SITE PLAN REVIEW

LOT NO. 10 REGISTERED PLAN. 434-2057

W Architect Inc.
DESIGN CONTROL REVIEW
JAN. 31, 2019
FINAL BY: MMI

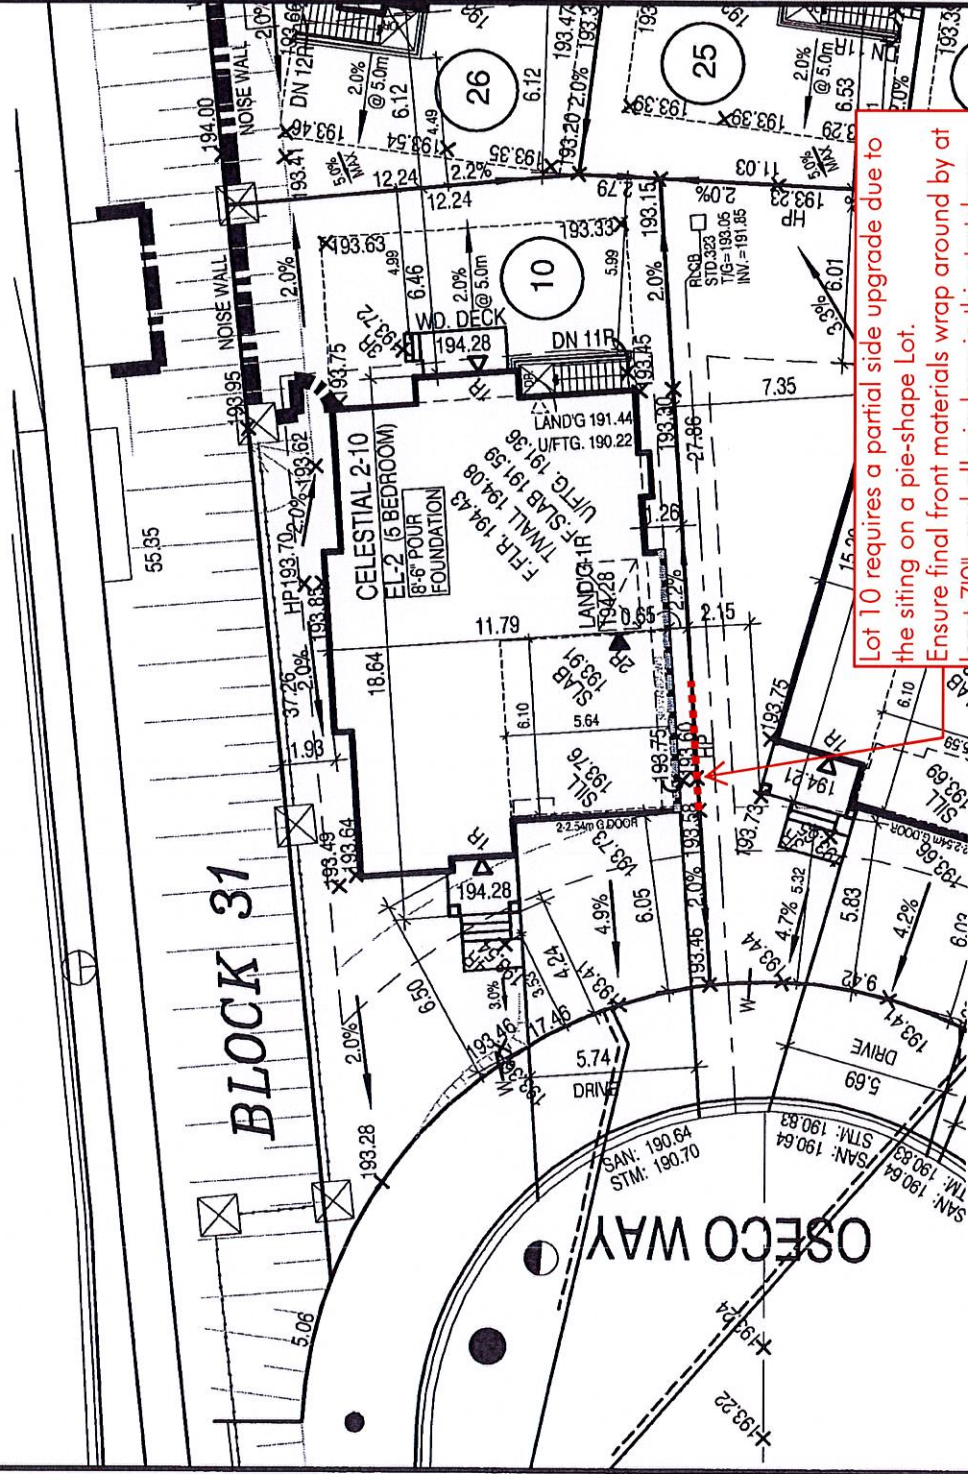
Lot 10 requires a partial side upgrade due to the siting on a pie-shape Lot. Ensure final front materials wrap around by at least 7'0", and all windows in this stretch are upgraded to match front (if existing)
